Rev.	Date	By	Description
			Drawing changed from 318_P_107
D	20.03.15	GL	Tender: Rainwater outlets revised. Levels added
C1	08.07.15	GL	CONSTRUCTION: Amendments as Addendum Bill - Zinc roof to skylights and zinc capping omitted. Replaced by Saranfil roofing membrane, flashings and roof trims.

RICHARD COBDEN PRIMARY SCHOOL, NURSERY
DRAWING : PROPOSED ROOF PLAN
SCALE : 1:50 at A1
DATE : 13.08.14

RICHARD COBDEN PRIMARY SCHOOL, NURSERY
 DRAWING : PROPOSED SECTIONS AA' + BB'
 SCALE : 1:50 at A1
 DATE : 22.08.14

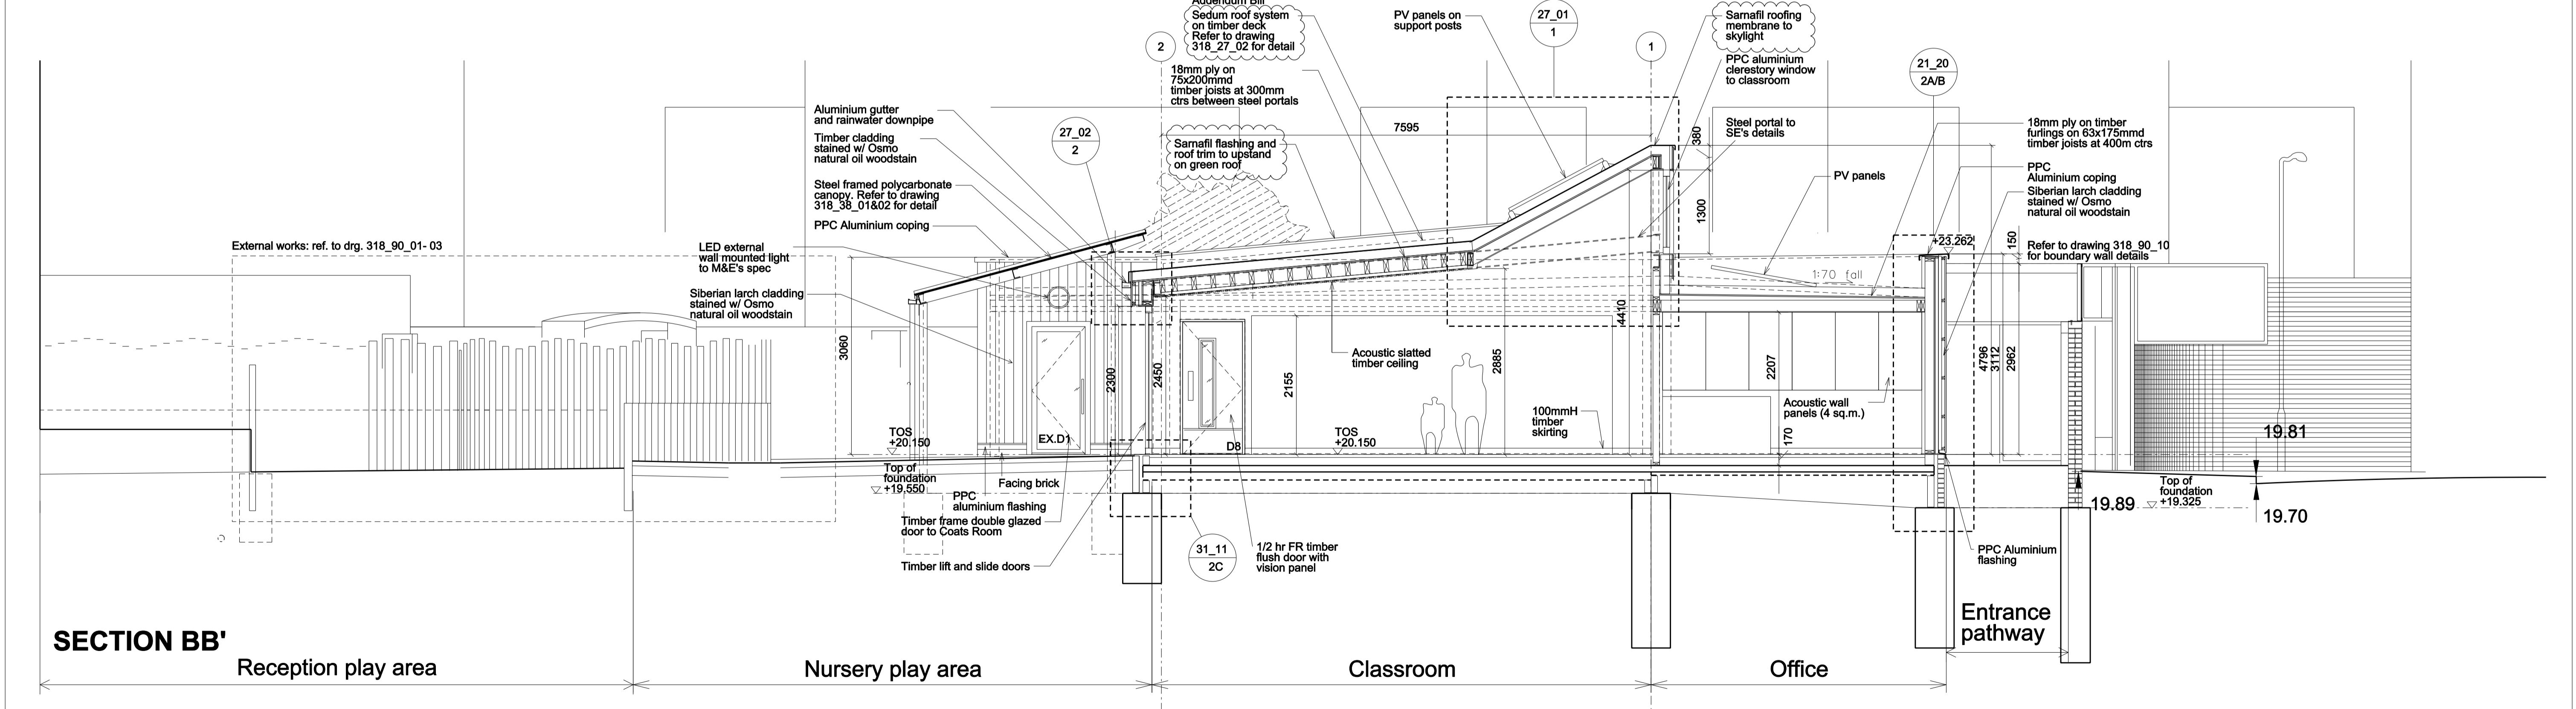
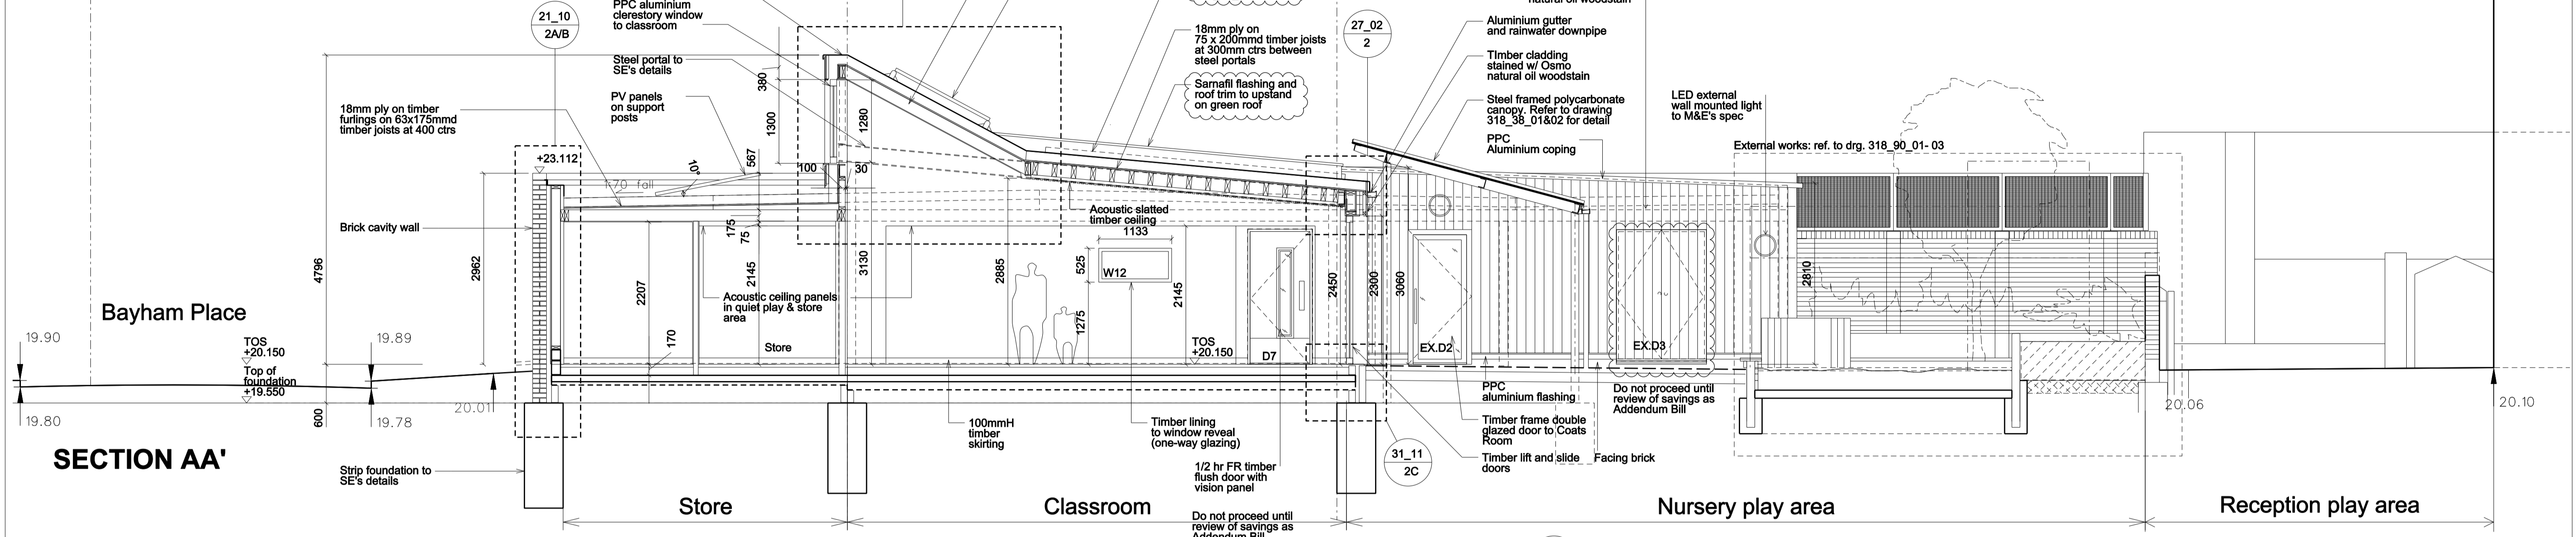
Rev.	Date	By	Description
			Drawing changed from 318_P_102
E	27.03.15		TENDER: GENERAL UPDATE
C1	08.07.15	GL	CONSTRUCTION: Amendments as addendum bill - zinc roof to skylights and zinc capping omitted, replaced by samafli roofing membrane, samametal flashing and roof trims.

RICHARD COBDEN PRIMARY SCHOOL, NURSERY
 DRAWING : PROPOSED SKYLIGHT DETAILS
 SCALE : 1:10 at A1
 DATE : 01.09.14

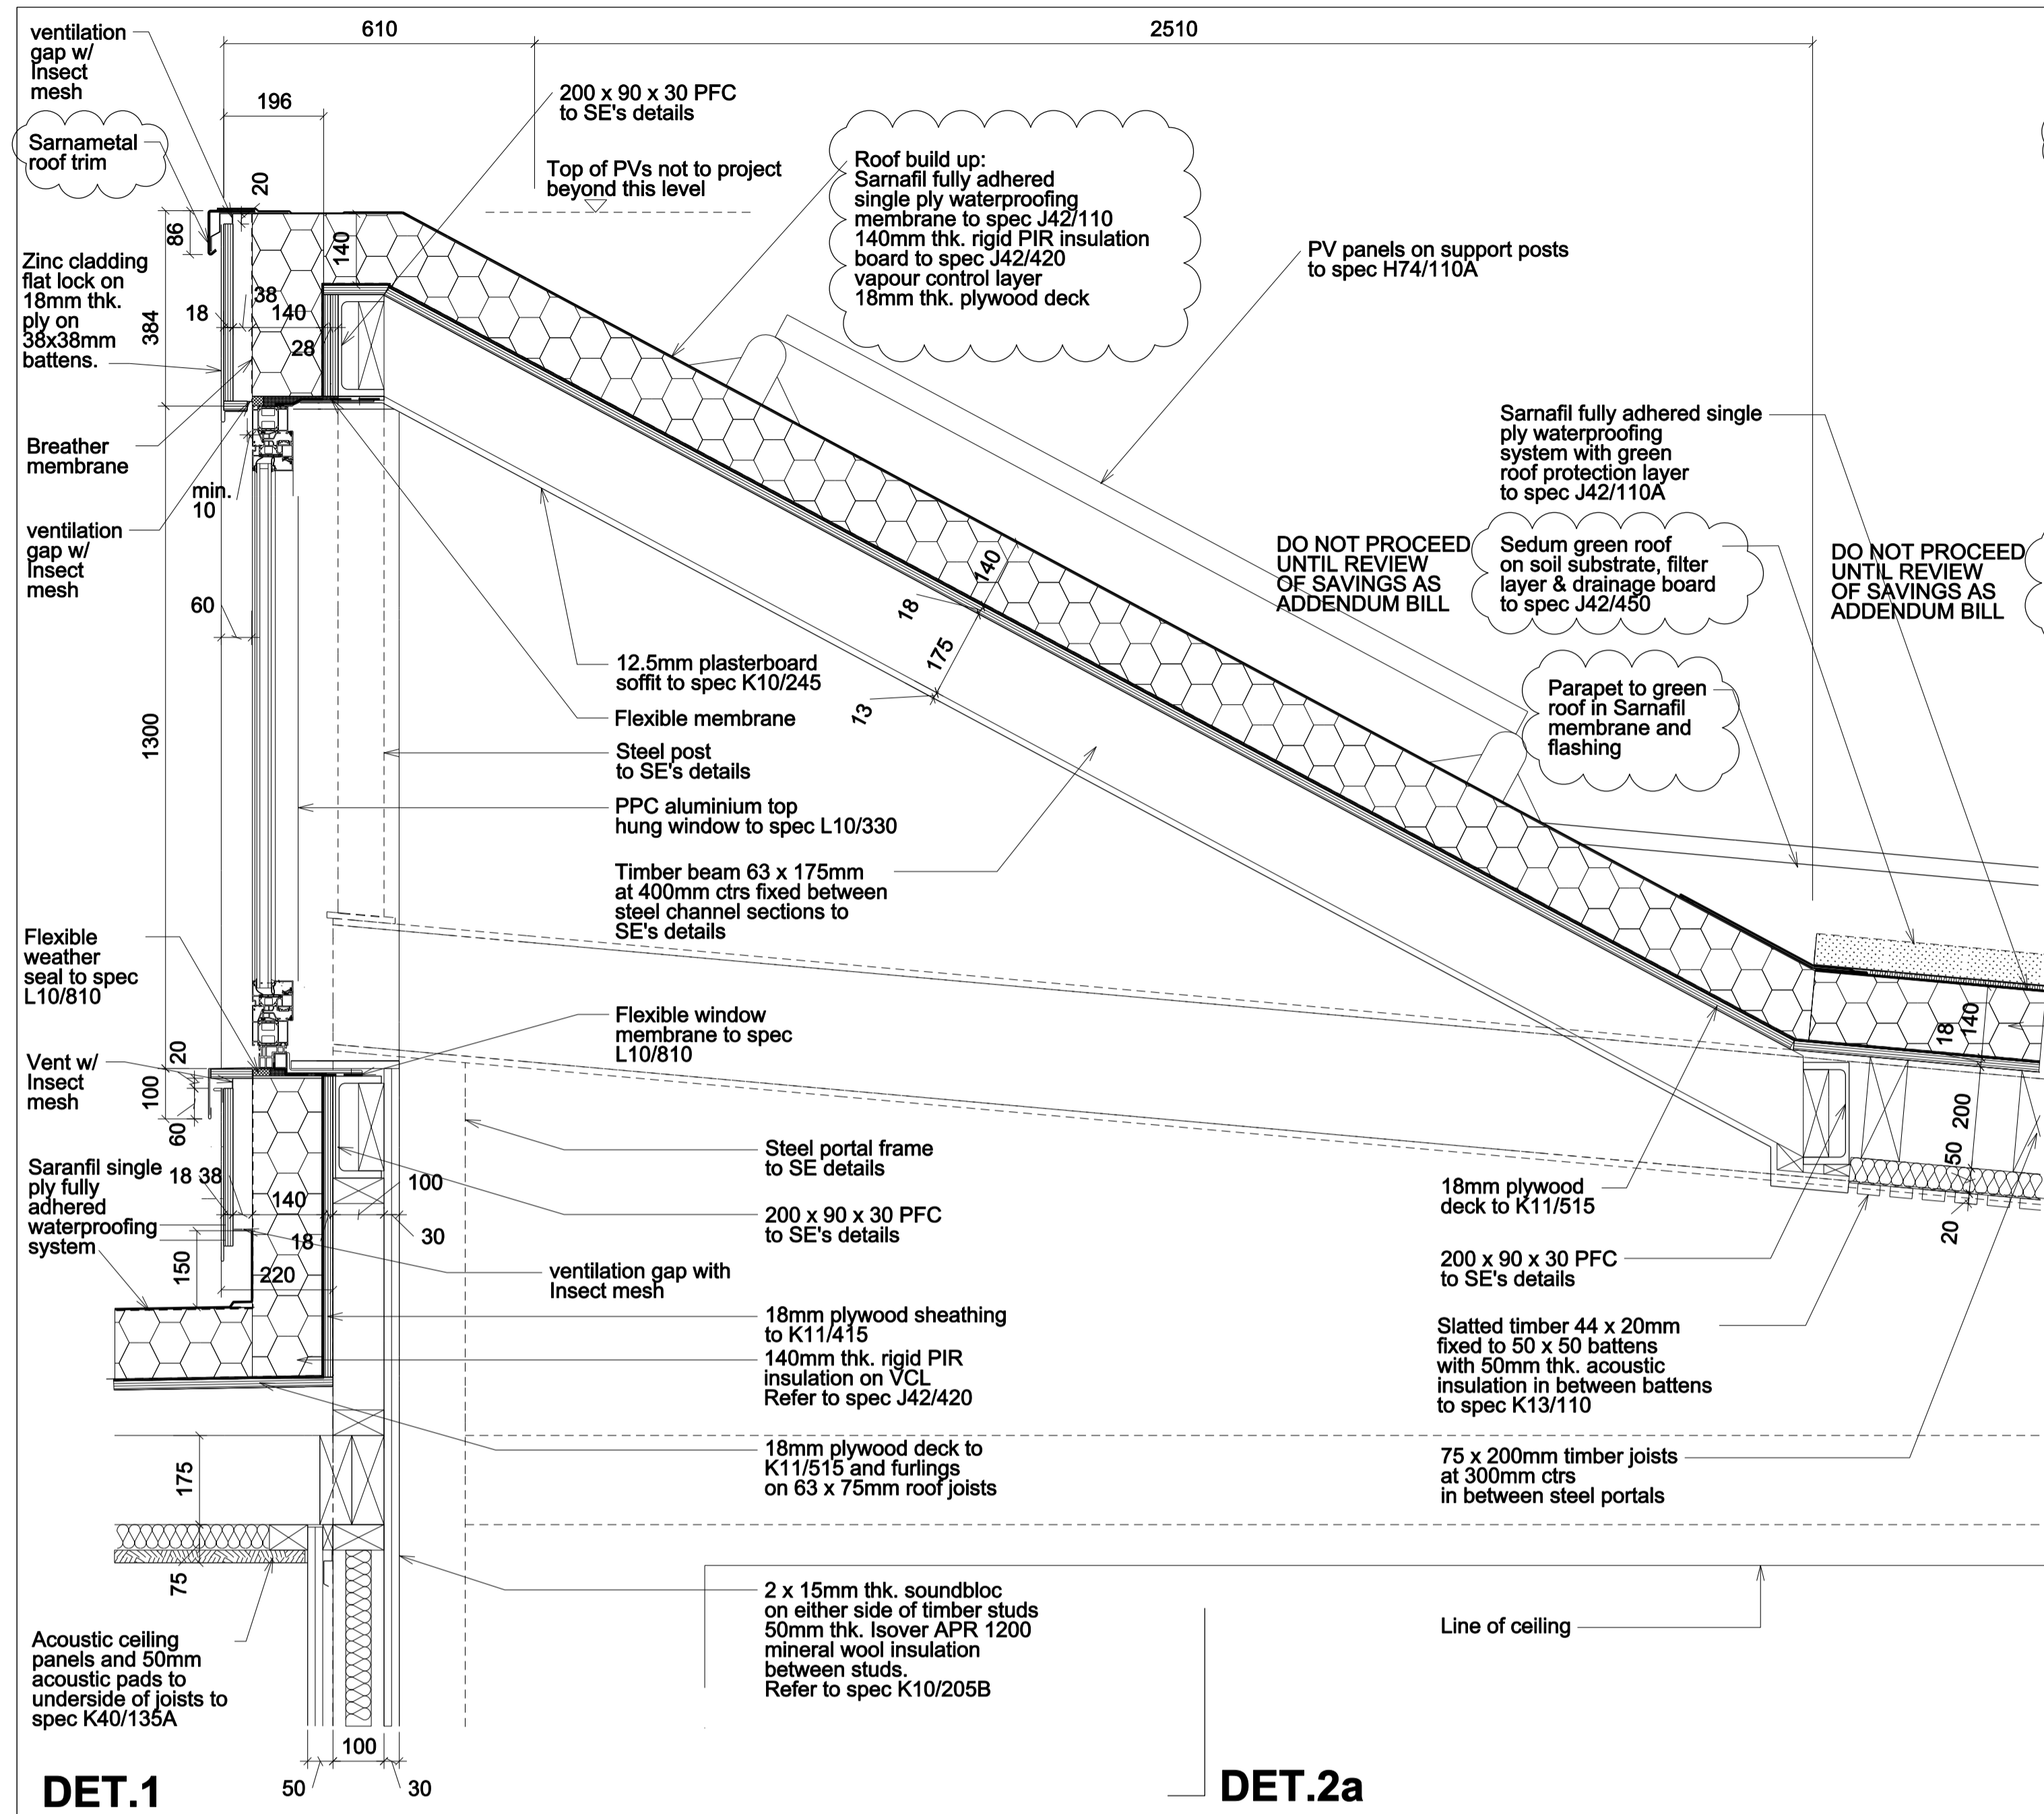
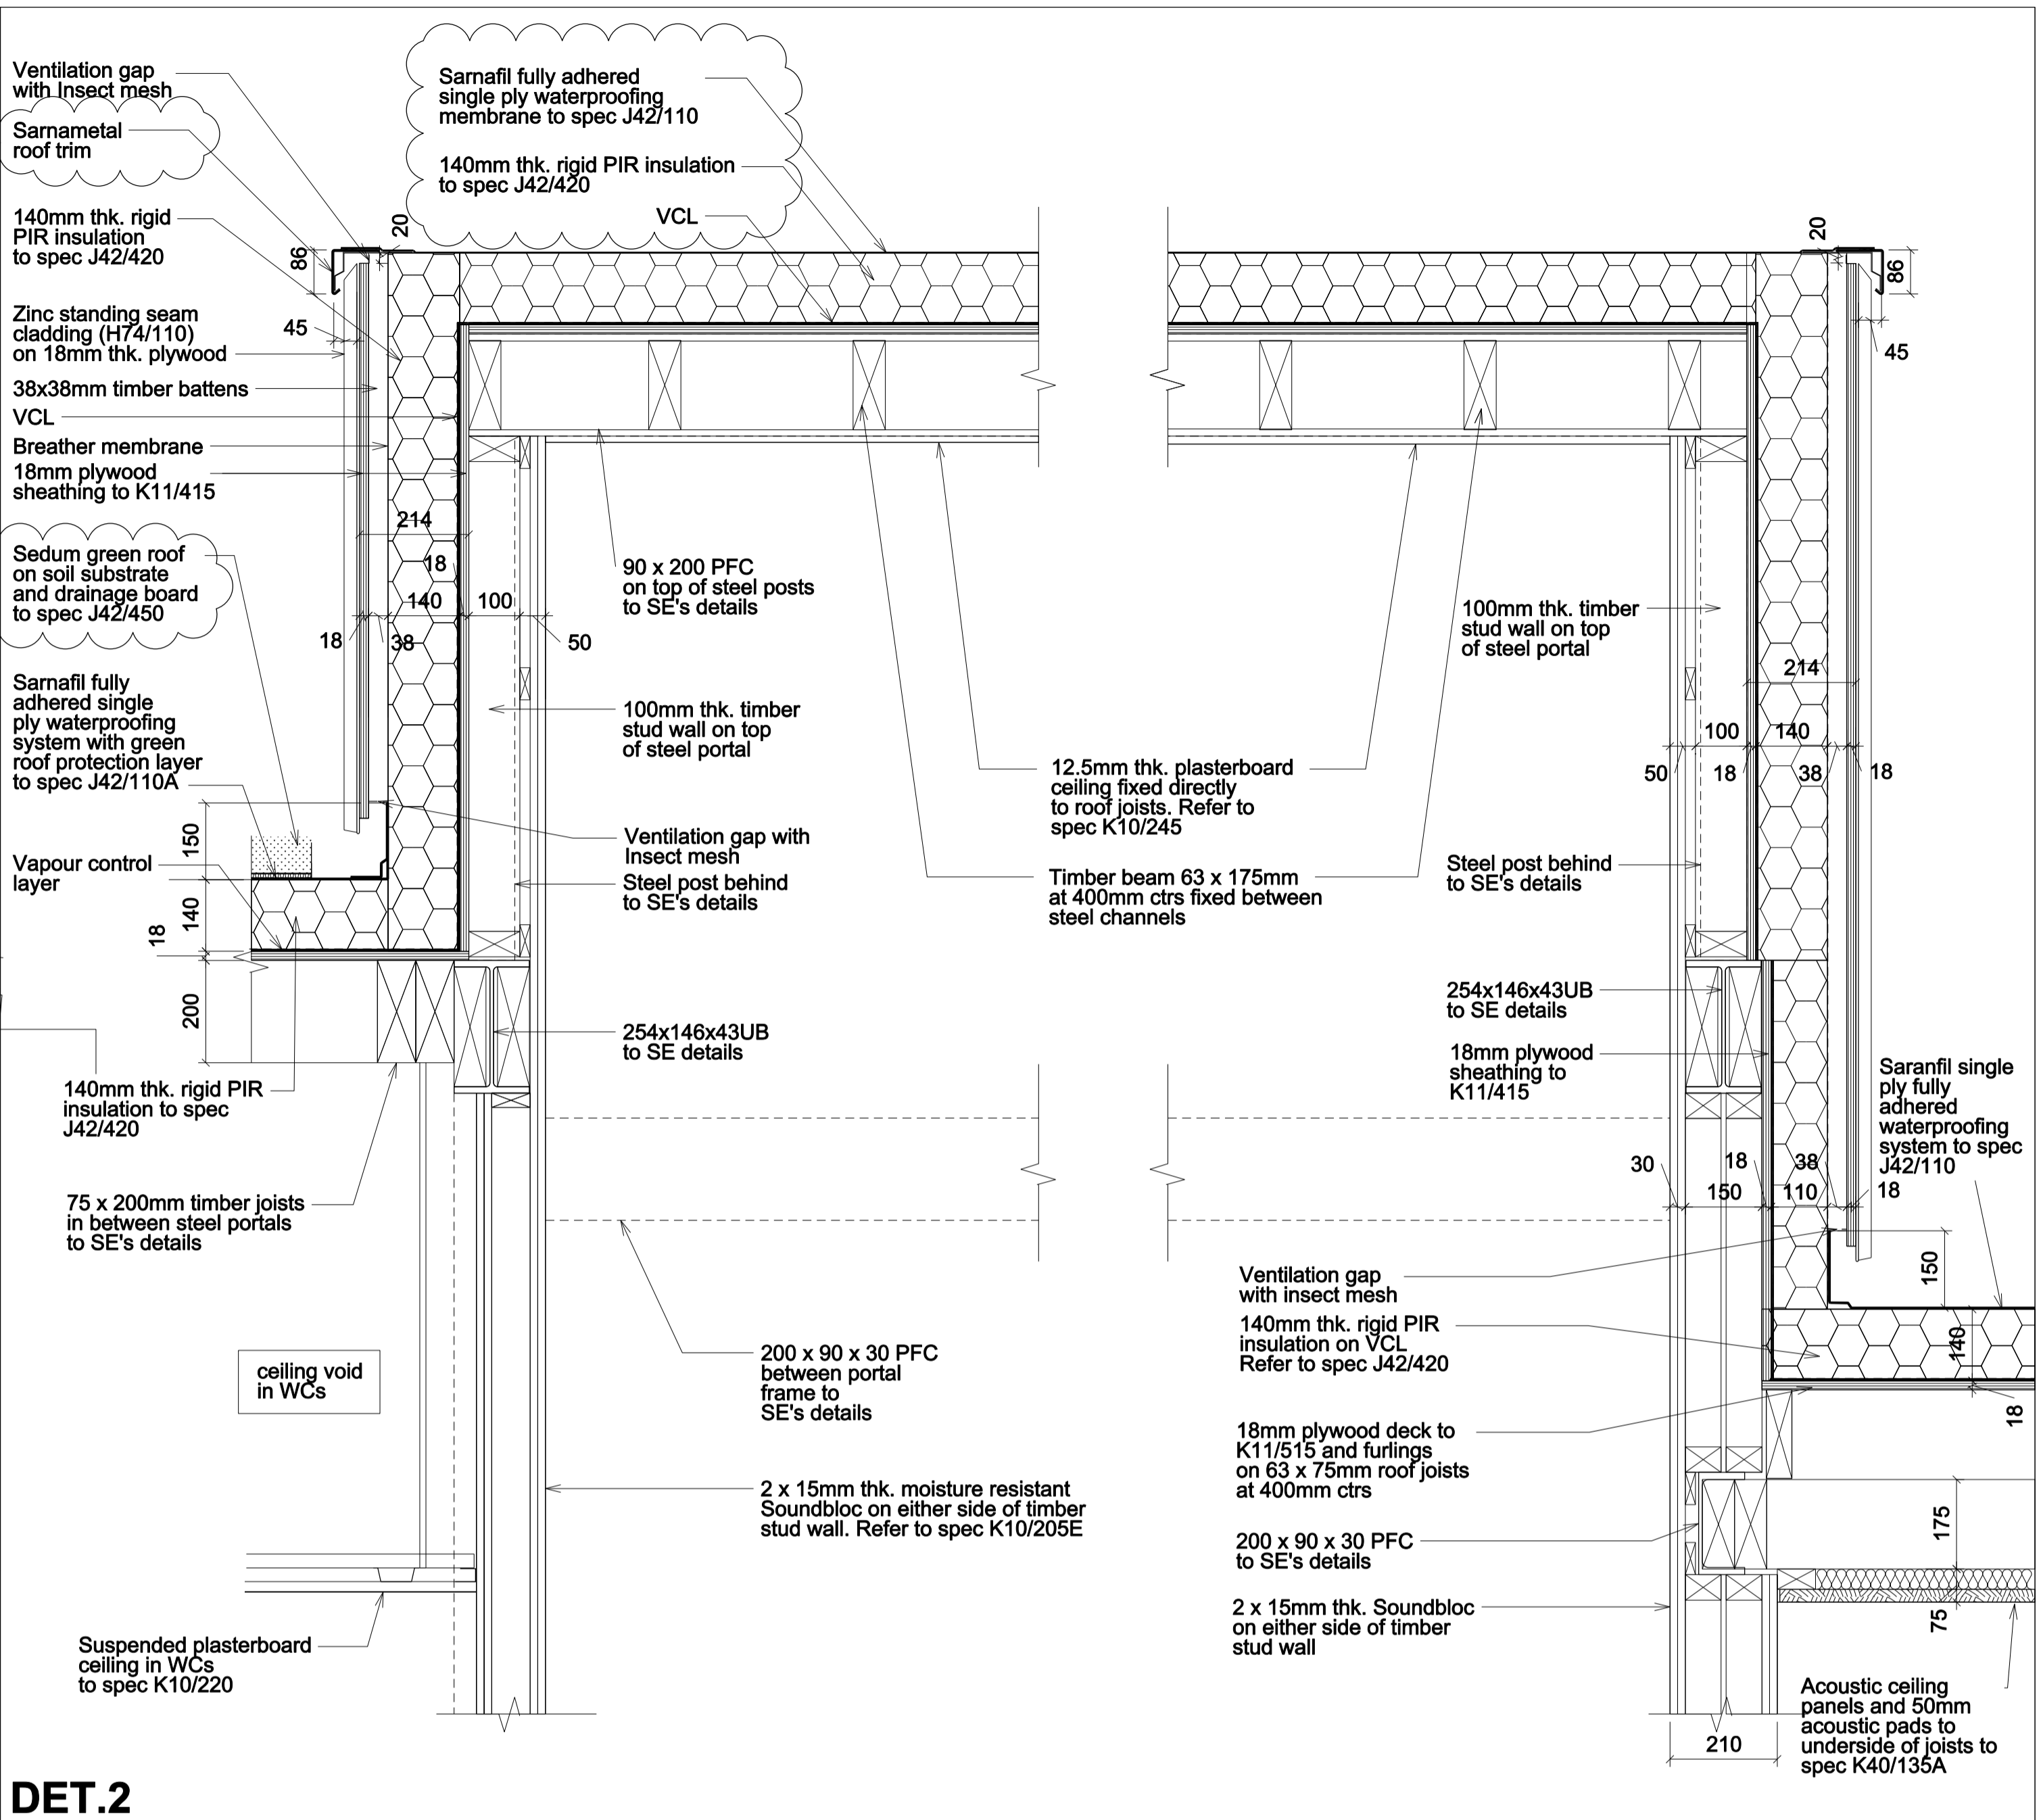
Rev.	Date	By	Description
B	30.03.15	GL	TENDER: NOTES UPDATED
C1	08.07.15	GL	CONSTRUCTION: Amendments as Addendum Bill - ballast margin at green roof omitted, zinc roofing & capping replaced by sarnafil roofing, flashings and roof trims
